**SDPA-12-1 & Special Exception S-2830, Wildwood Medical Center, LLC**

**Description**

SDPA 12-1 is a request to amend a previously approved schematic development plan in order to replace a 3-story office building with a 5-story, 58 unit residential apartment building.  
S-2830 is a special exception request to permit the construction of 58 residential units in the O-M Zone. Of these 58 units, 35% (21 units) are proposed as productivity housing units under the special exception provisions of Sec. 59-G-2.36.2(b)(2).

THE MAP SHOWS  
**SPECIAL EXCEPTION PLAN**  
**WILDWOOD MANOR SHOPPING CENTER, PARCEL B**  
**THE FLATS AT WILDWOOD**  
 PLAT 17744

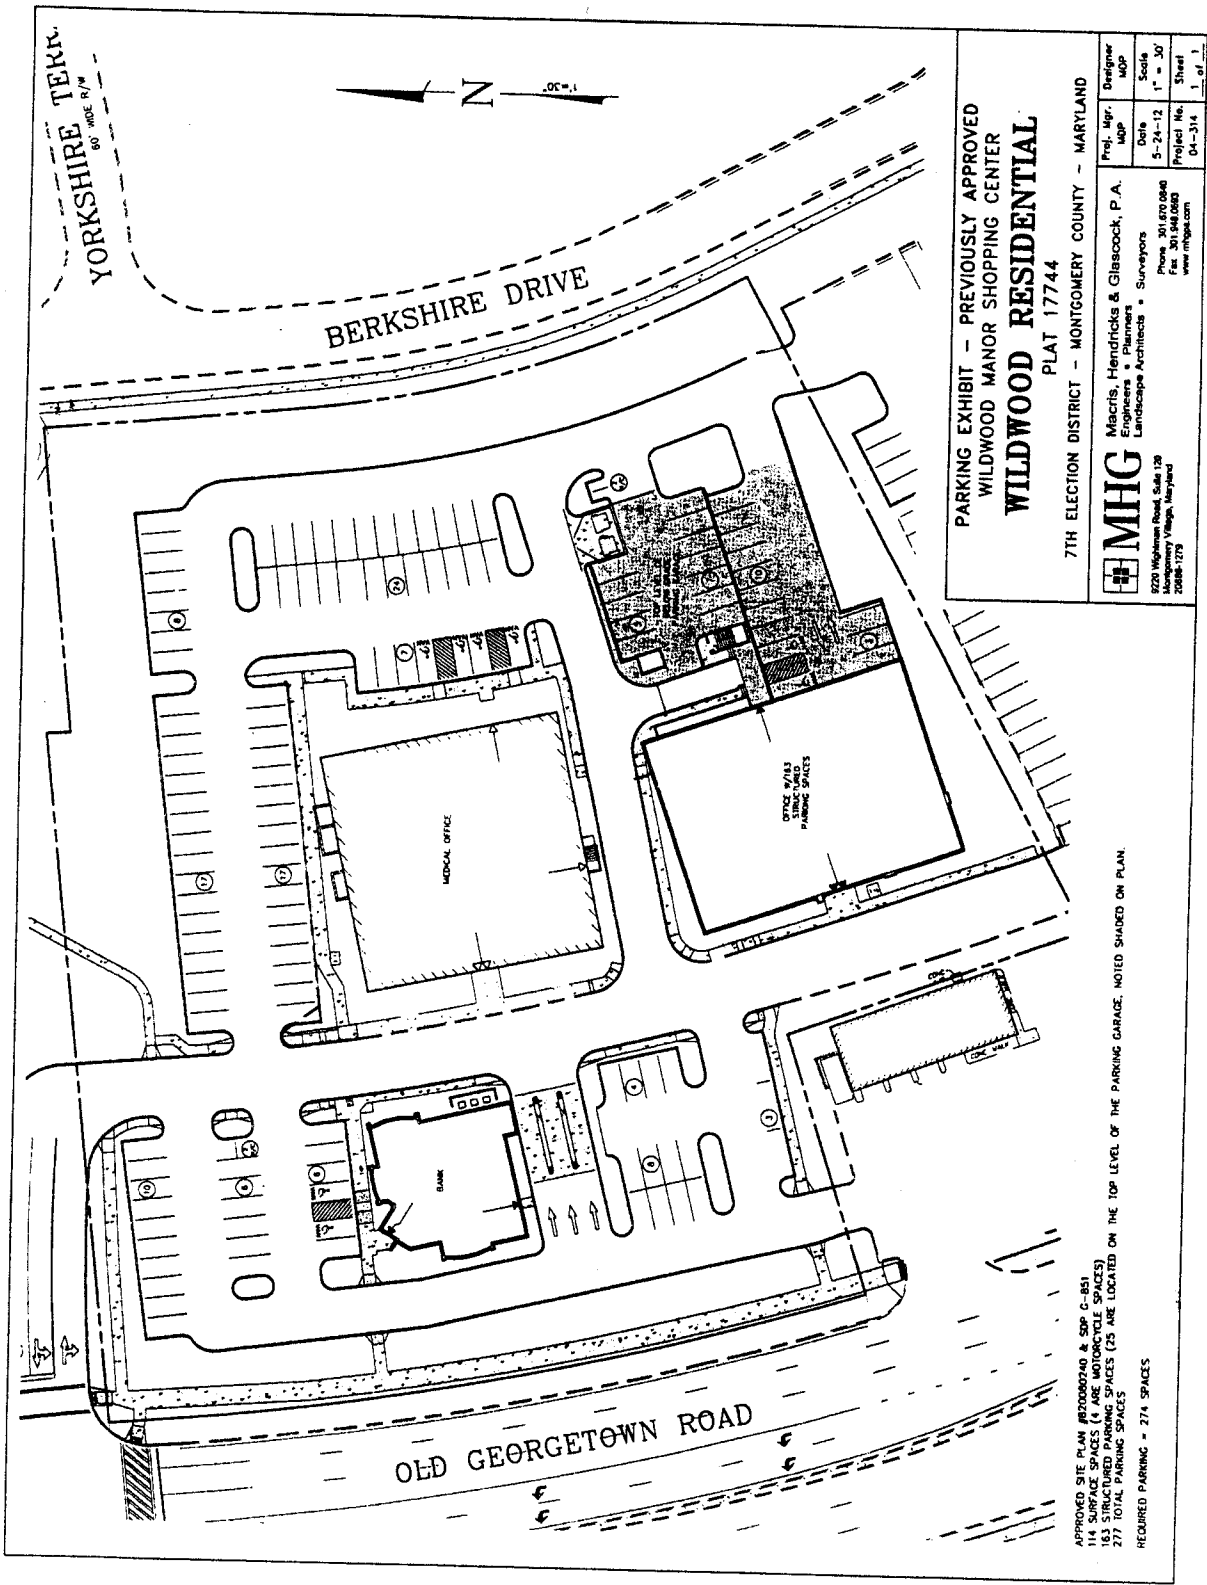
1. The Applicant maintains that 227 parking spaces are being provided and the plans submitted only depict 225: 111 surface and 114 garage.
2. Under Section 59-G-2.36.2(b)(4), "A minimum of one (1) on-site parking space per dwelling unit must be provided. Additional parking *spaces must be provided up to the total required by the relevant standards of Section 59-E-3.7*, except that *the Board may approve shared parking in accordance with the provisions of Section 59-E-3.1 to accommodate these additional spaces*" (*emphasis added*). Thus, the correct calculation is 1.25 spaces per 1-bedroom and 1.5 spaces per 2-bedroom, regardless of whether the units are productivity housing or not. One space is the minimum so the Applicant could not provide less through any sort of waiver or other provision in the code, but they *must* provide additional spaces up to the total required by 59-E-3.7. Eighty-seven (87) spaces are required for the residential building and 247 for the overall site if the shared parking calculation is not used.

3. The provision that the Board of Appeals (BOA) may approve shared parking allows the applicant to calculate under Section 59-E-3.1. Under Section 59-E-3.1, the shared parking provisions allow an Applicant to calculate parking based on a matrix covering various parking scenarios, namely, weekday, weekend, daytime, and evening. In this case, the Applicant incorrectly placed the bank parking under “retail”, although the base parking calculation was made under “office”. The correct calculation should be 160 office spaces and 87 residential spaces. Testing under the various parking scenarios, the scenario requiring the most uses must be accommodated. In this case, it is the weekday daytime scenario, which requires provision of at least 204 spaces. The Applicant is providing 225 spaces, which is above the minimum required. The Applicant has provided six reasons why the Board of Appeals should accept the shared parking calculation (Attached) and staff agrees with all but one of them: “The fact that the ‘Required parking is only nine (9) spaces more than actual ‘Provided’ parking (236 required – 227 provided = 9)”. As shown, these numbers are incorrect (should be 236 – 225 = 11) but the minimum number of spaces are provided and supported by the analysis. If the BOA does not accept the shared parking analysis allowed by the Ordinance, a larger garage underneath the residential building should be built to satisfy the non-shared parking requirement for this site.

4. The submitted special exception site plan and the amended schematic development plan shows that the existing 3-story medical office building footprint consists of 36,423 square feet. The Applicant maintains that 6,423 square feet of that number is identified as storage area and does not count towards the parking requirement as allowed under 59-E-3.7. Therefore, the Applicant is basing the parking requirement on 30,000 square feet of building space which requires 150 parking spaces. Staff notes that in previous approvals, including rezoning, preliminary plan and site plan, the parking requirement was based on 36,423 square feet which was approved with 183 parking spaces under the approved site plan 2009. The Applicant states that the building has been renovated since that time, and a more precise allocation of building space was conducted that identifies the storage area which does count towards required parking. To date, the Applicant has not submitted a precise survey of the existing building that shows 6,423 square feet of storage area. The Applicant notes that to the extent that parking calculations shown on previous approvals for the subject site included gross floor area associated with storage area in the building, they were in error.
